TE RUNANGA O NGĀI TAHU

COMMENTS ON THE DRAFT CENTRAL CITY PLAN (Volumes 1 and 2)

ATTACHMENT TWO
RETAIL FLOOR AREA PLAN

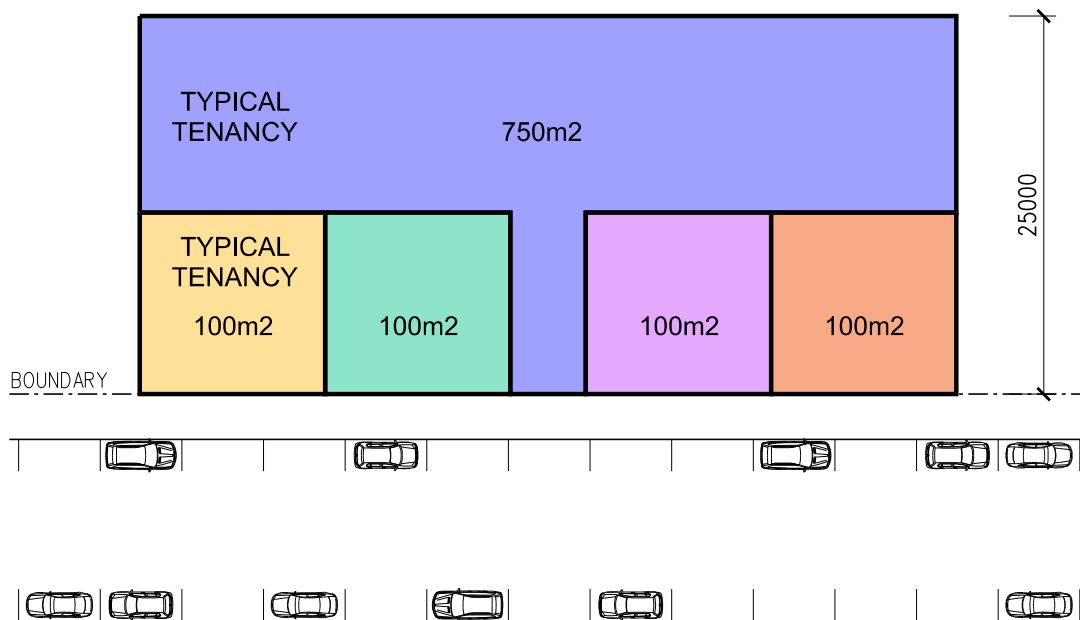
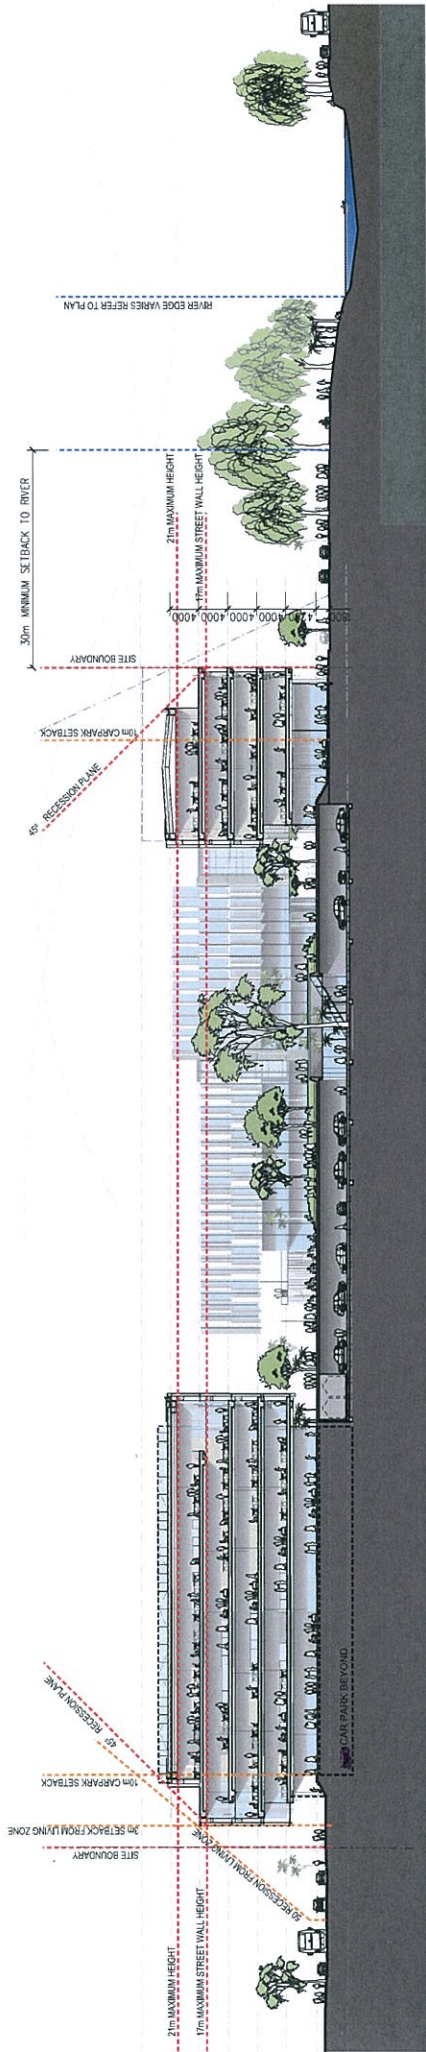
| Limits on retail floor space – Proposed Rule 2.2.5(2) (Volume 3, Part 3), p. 58 | Oppose | NGĀI TAHU is opposed to this minimum requirement as it discourages a number of retailers from either re-establishing or making a decision to establish within Christchurch's central city. Discouraging this retail activity will not enable recovery, rather, it will hinder recovery and |

| | | <p>ultimately impact on the CCP’s vision for a vibrant, sustainable and resilient central city.</p> <p>NGĀI TAHU has assessed the reason for this limit and have found that the standard is tied to an aspiration for attracting certain types of retail activities into the central city and keeping certain types out. The CCP doesn’t state this, but it is also interpreted that the CCP is looking for a “boutique” approach to retail activities within the core.</p> <p>The type of retail activity that the rule aims to keep out of the central city is that such as Rebel Sports which is referred to on page 59 (Volume 2) by way of a description of it’s current location. The market alone will dictate whether this type (size) of retail activity is able to establish in the core for a number of reasons including:</p> <ul style="list-style-type: none"> • The availability of a retail tenancy of this size and appearance. • The cost of a tenancy to accommodate this type/size of tenancy given the value of land within the core, compared to the central city south area. <p>It is noted that even if a retail activity such as Rebel Sports , or other pre-existing activities such as Kathmandu, Country Road or Whitcoulls, wished to establish or re-establish within the central city the appearance of the activity from the street would be dictated by the tenancy in which it is occupying. It is possible to have retail activities that are greater than 450m², yet still achieve a small format appearance in terms of the entry as viewed from the street. Such outcomes can be achieved as shown on the attached Plan in Attachment Two.</p> |

ATTACHMENT THREE
PLAN SHOWING IMPACTS OF RECESSION PLANE RULES

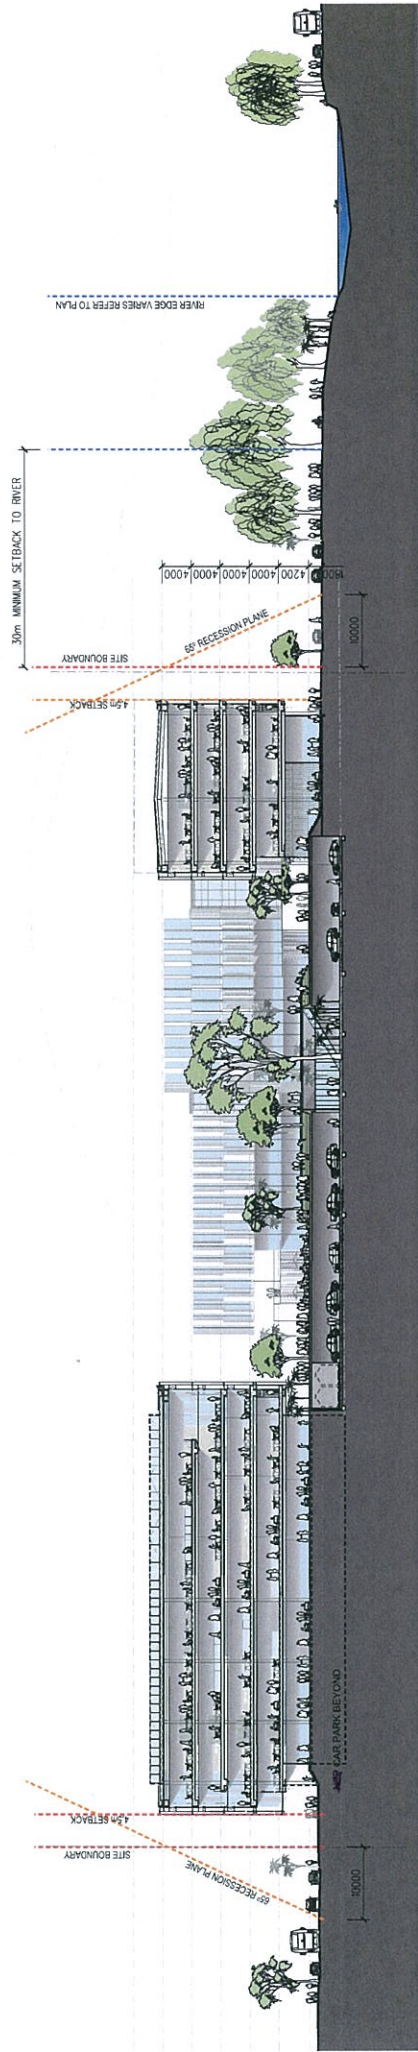
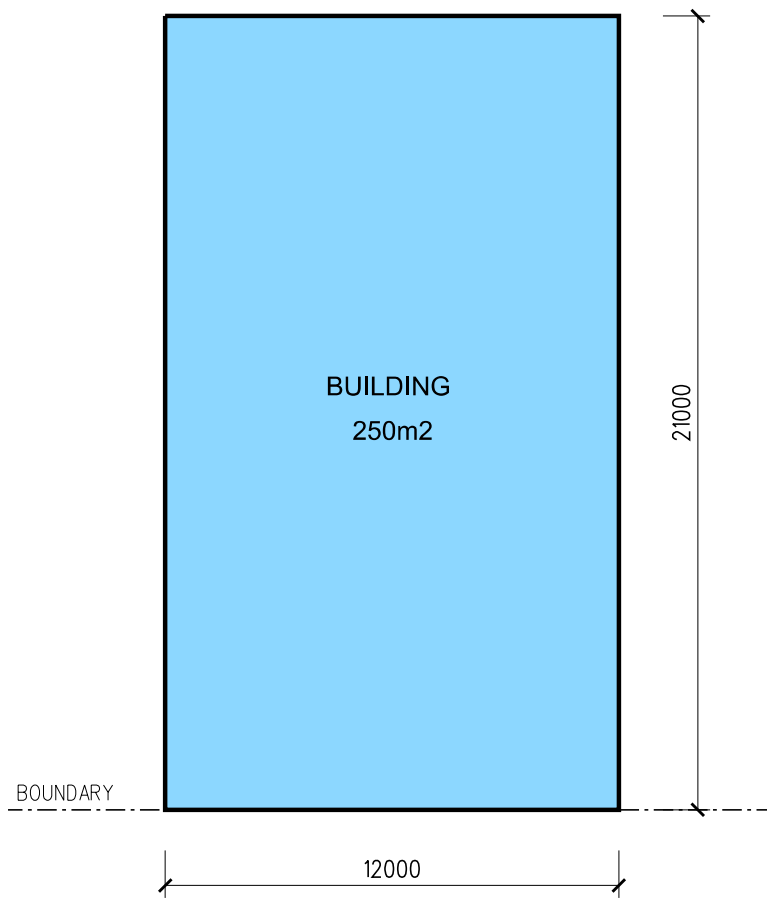
| <p>Recession Planes on Road Boundary – Proposed rule 2.2.1 – 1.1 (Volume 3, part 3), p.45</p> | <p>Oppose</p> | <p>NGĀI TAHU is of the view that the new recession plane requirement within the central city will result in design outcomes that may not be reflective of function.</p> <p>NGĀI TAHU questions the intention of the recession plane requirement in the context of shading mitigation, given that the CCP proposes a low rise built form across the city in order to mitigate shading of roads and public spaces. NGĀI TAHU is of the view that the recession plane requirement will create steps in the upper levels of buildings that may be unnecessary. If it is intended that the upper levels include decks, these may not be appropriate along certain road frontages due to</p> |

| | | <p>weather considerations and the usability of these spaces.</p> <p>NGĀI TAHU seeks clarity on the need for this rule in design terms. Within this context it is noted that the current City Plan rule requires a 65 degree recession plane from a point measured 10m into the road from the site boundary.</p> <p>The result of the existing City Plan and proposed CCP recession plane requirements are shown on the plan attached as Attachment Three.</p> |

ATTACHMENT FOUR
PLAN SHOWING IMPACTS OF CCP STANDARD 2.4.3(C)
PARKING FOR PEOPLE WITH DISABILITIES

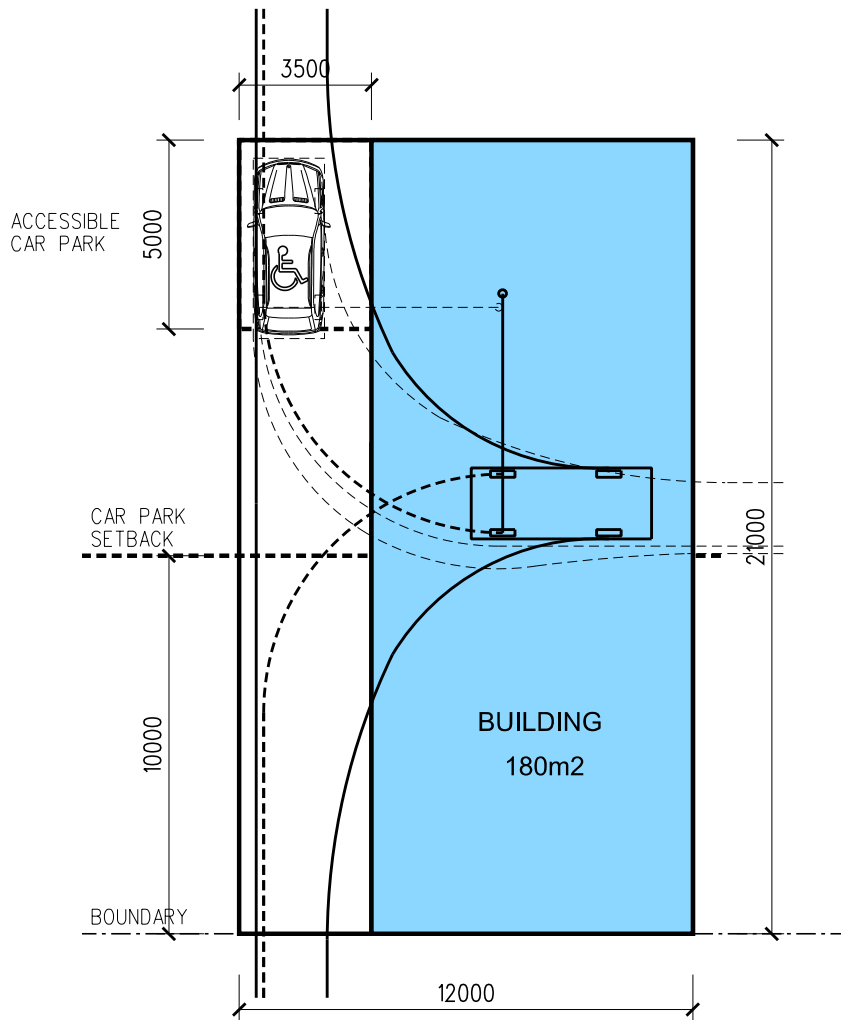
| <p>Parking spaces for people with disabilities – Central City Zones - Rule 2.4.3 (c) (Volume 2, page 134)</p> | <p>Clarify</p> | <p>NGĀI TAHU supports the provision of parking spaces for people with disabilities in all parking areas , however notes the provision requiring all buildings with a Gross Floor Area of 1500m2 or higher are required to provide parking spaces for people with disabilities, even if no other parking spaces are provided. Appendix Four includes a diagram showing the implications of this standard. NGĀI TAHU seeks clarification on whether the plan intends for this to be the case as the requirement will also require access, manoeuvring, and associated area on site for this space.NGĀI TAHU,</p> |
